LiDAR Quality Assessment Report

NRCS Lauderdale MS 0.7m NPS Lidar

NGTOC
2014-02-13

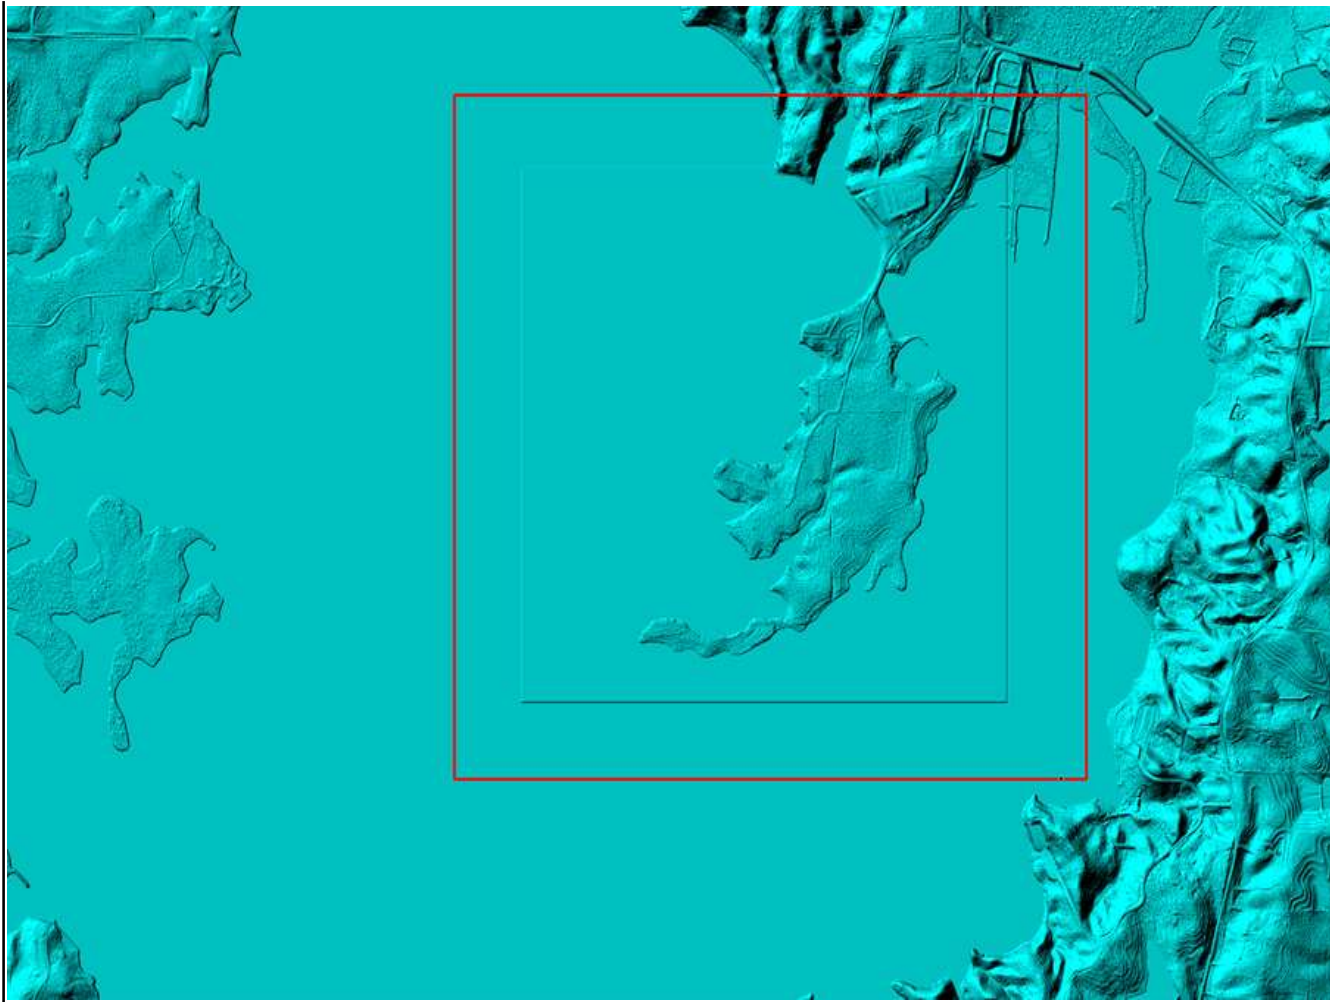
DEM tiles properly edge match and free of edge artifacts

Edge mismatch along tiles 16SCA300985 and 16SCA315955 (pictured)

Waterbody at 33° 05' 43.8346" N, 89° 00' 23.3096" W, tile 16SCB120630 - representative image

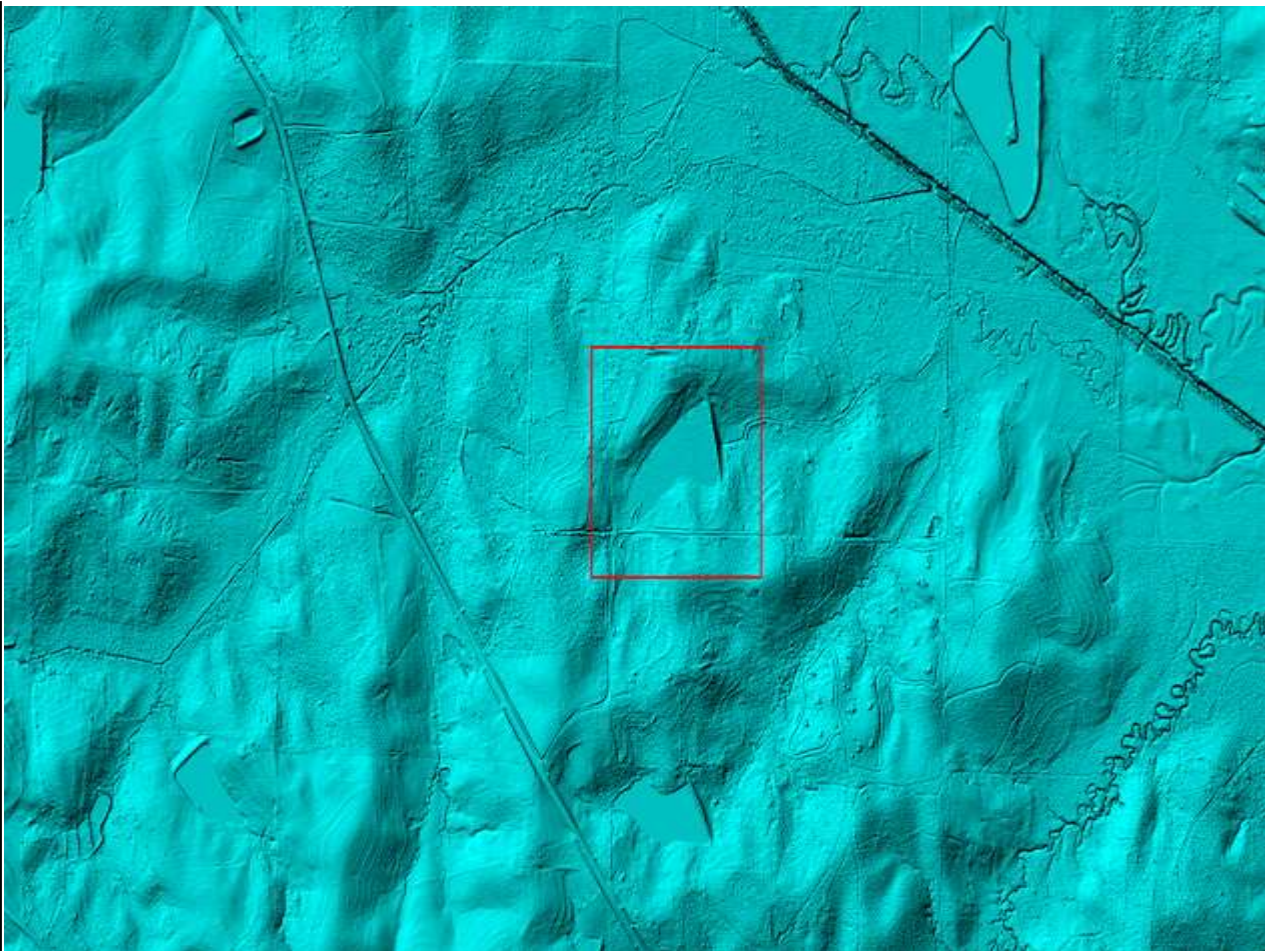
Waterbodies 2 Acers or greater are flattened

Several waterbodies greater than 2 acres need hydroflattening:

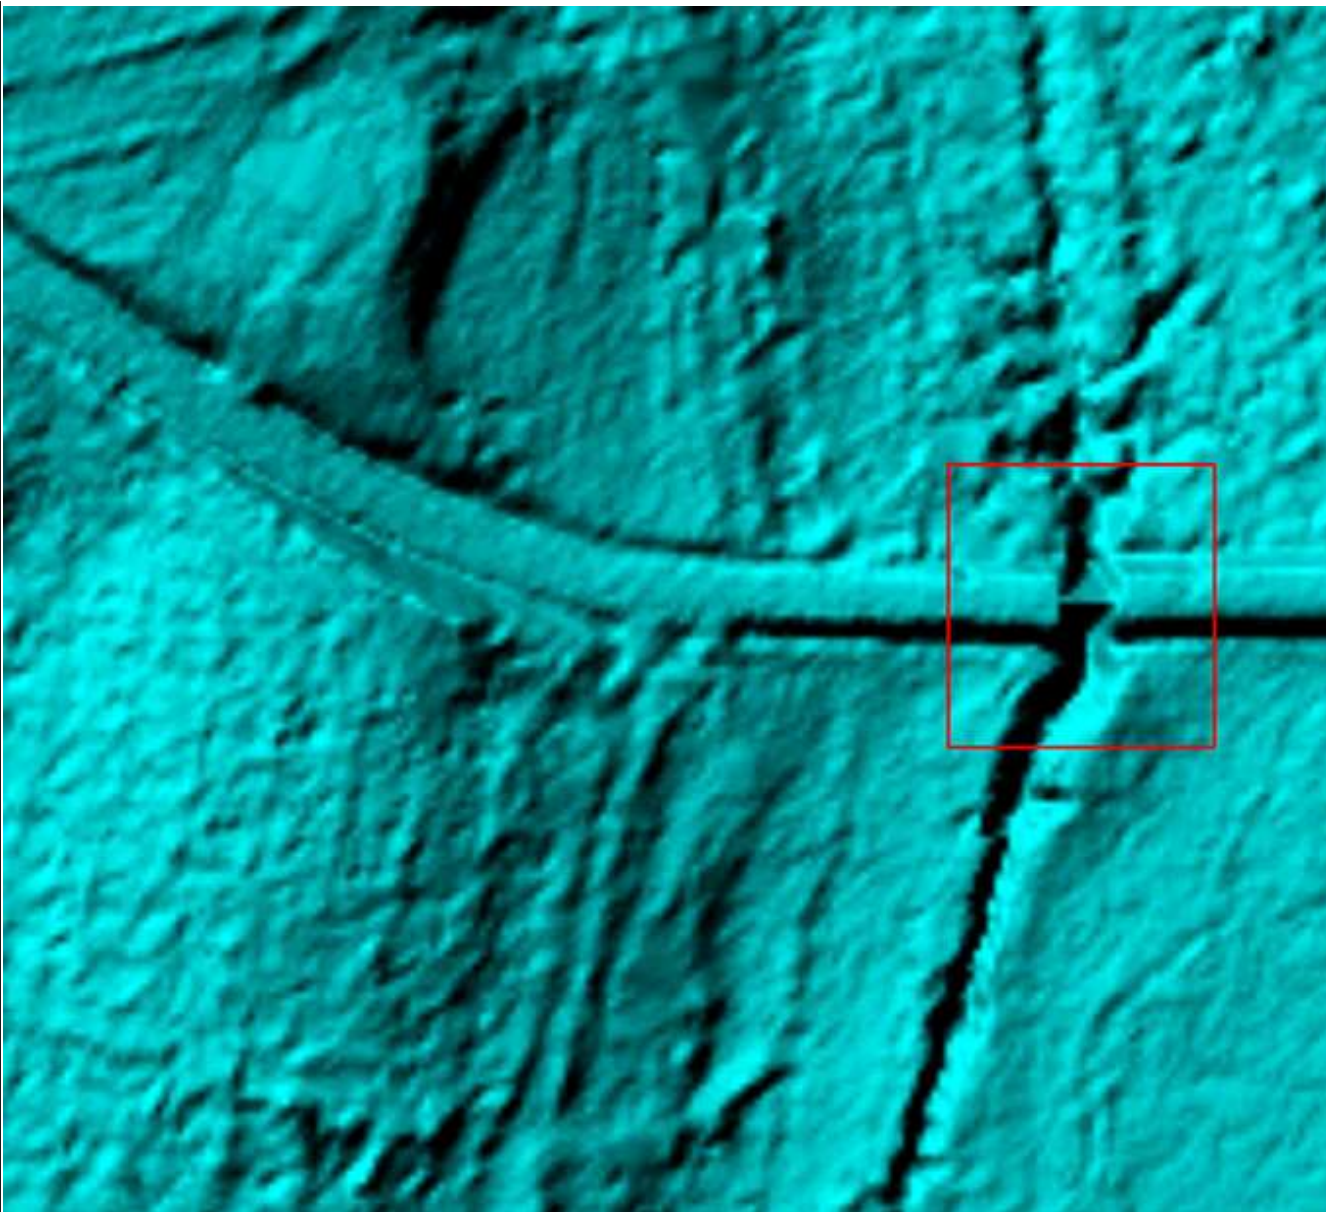
Bridges/Overpasses are properly removed

Two partial bridge removals, one at 32° 52' 17.2253" N, 88° 52' 43.9374" W, tile 16SCB240375 (pictured) and tile 16SCA315700:

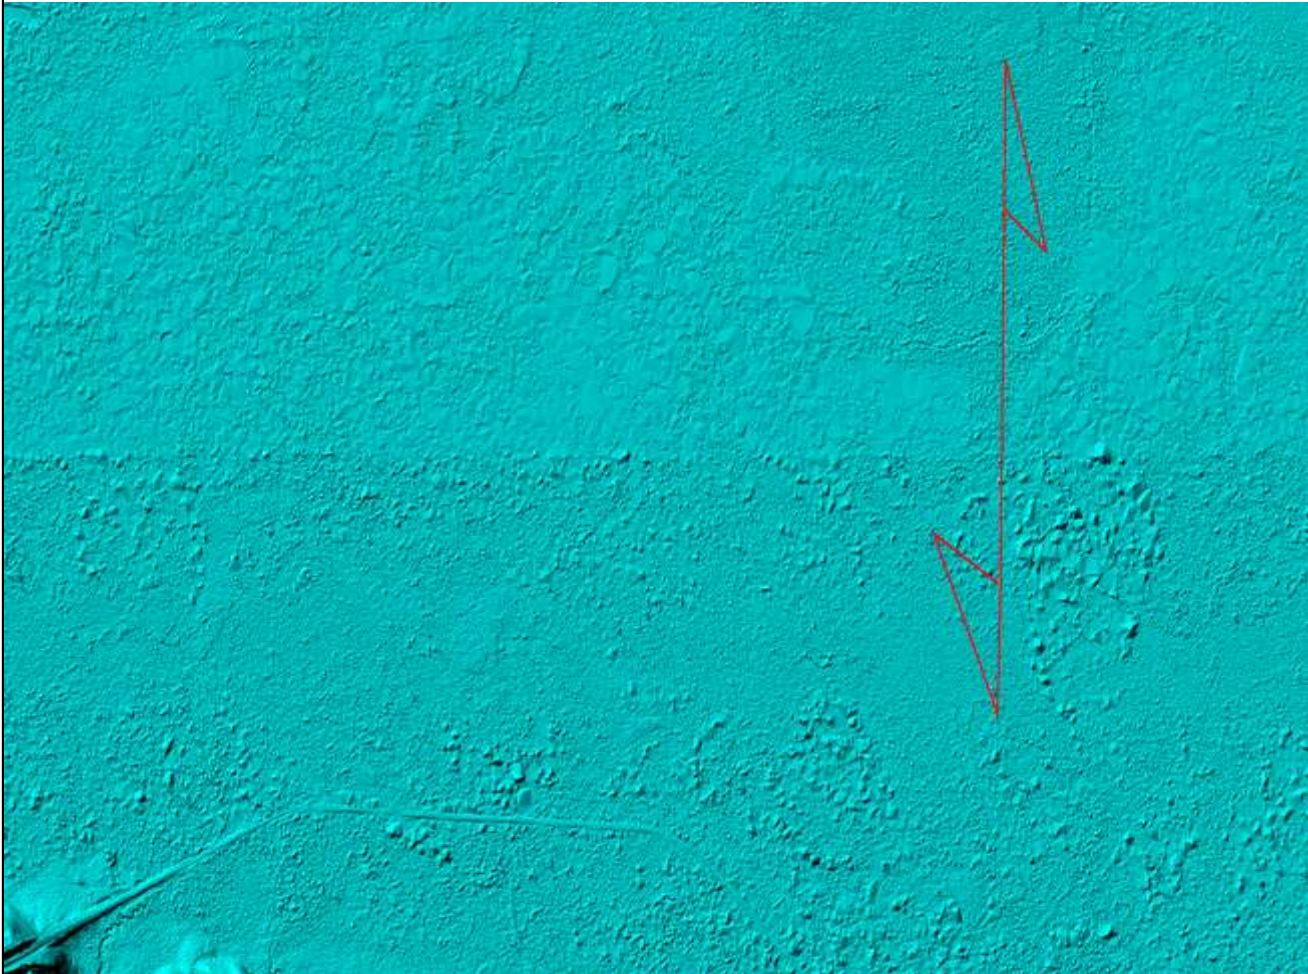
DEM TILES Either Missing or have Missing Data (16SCB600195, 16SCB405420, 16RCA600295, 16SCB690120, 16SCa240910,

16SCB315000. Ridge between hydro flattened tiles at 16SCB315000 and vicinity

Edge match error; tiles possibly of different resolutions along tiles 16SBB895330 and 16SBB895345:

**** All issues were fixed by the contractor.**
